<b>SUNDRY NOTICES AND REPORTS ON WELLS</b> (DO NOT USE THIS FORM FOR PROPOSALS TO DRILL OR TO DEEPEN OR PLUG BACK TO A DIFFERENT RESERVOIR. USE "APPLICATION FOR PERMIT" (FORM C-101) FOR SUCH PROPOSALS.)		WELL API NO 30-015-24129
1 Type of Well: Oil Well <input type="checkbox"/> Gas Well <input checked="" type="checkbox"/> Other		5 Indicate Type of Lease STATE <input checked="" type="checkbox"/> FEE <input type="checkbox"/>
2 Name of Operator Devon Energy Productin Company L. P		6. State Oil & Gas Lease No.
3 Address of Operator 20 N Broadway, Oklahoma City, OK 73102		7 Lease Name or Unit Agreement Name Craft

Revised T.A. procedure due to production packer being stuck in the hole.

Well Name: CRAFT #1		Field: PIERCE CROSSING NORTHWEST	
Location: 1980' FNL & 660' FWL, SEC 13-T24S-R28E		County: EDDY	State: NM
Elevation: 2994' KB; 2972' GL; 22' KB-GL		Spud Date: 4/30/82	Compl Date: 9/23/82
API#: 30-015-24129	Prepared by: Ronnie Slack	Date: 4/4/11	Rev:

**PROPOSED TA WELLBORE  
REVISED 4/4/11**

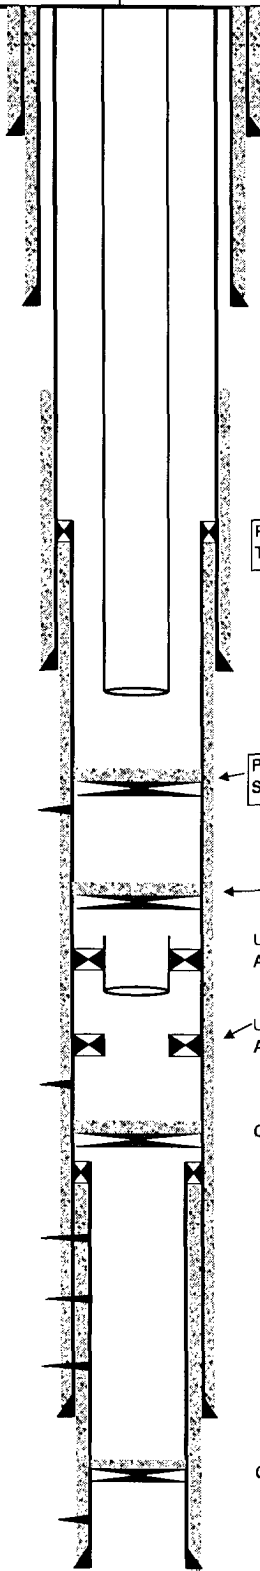
1. Released from on-off tool and pull out of hole with tubing.
2. Set CIBP above packer at 11,050' Cap with 35' cement.
3. Set CIBP at 10,800' and cap with 35' cement.
4. TIH with 2-7/8" production tubing to 10,000' +/-
5. Notify OCD of intent to run MIT 24 hours in advance. Circulate well with lease water
6. Pressure up and run MIT for 30 minutes and chart. Submit pressure chart and sundry to OCD
7. Request TA for one year

Proposed TA  
TIH w/ +/- 10000' 2-7/8" prod tubing

Proposed TA  
Set CIBP +/- 10800'. Cap w/35' cement

Proposed TA  
Set CIBP +/- 11050'. Cap w/35' cement

Unable to release pkr. Released On/Off & POOH (4/4/11)  
Arrowset packer @ 11092' (1/1/09)
